## ADDENDUM 1

DATE: May 25<sup>nd</sup>, 2018  
 PROJECT: MSB Penthouse AHU Replacement  
 ITB NO: 744-R1816 MSB Penthouse AHU Replacement  
 OWNER: The University of Texas Health Science Center at Houston  
 TO: Prospective Proposers

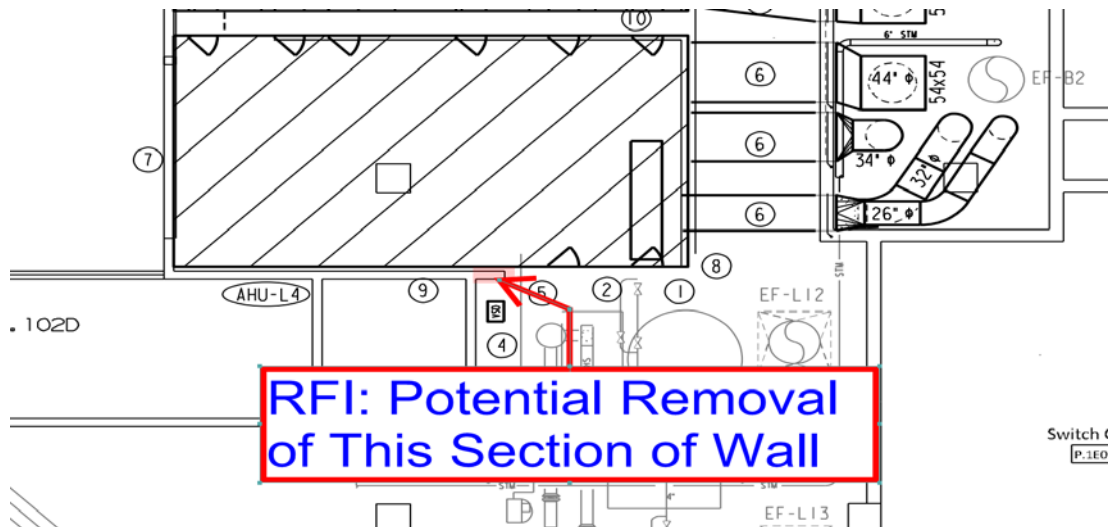
40.	M318		Would it be possible to eliminate the shaded section of wall in the drawing below to facilitate the location of the cooling coil condensate exit from the unit, and the condensate collection/reclamation tank?	Do not remove.
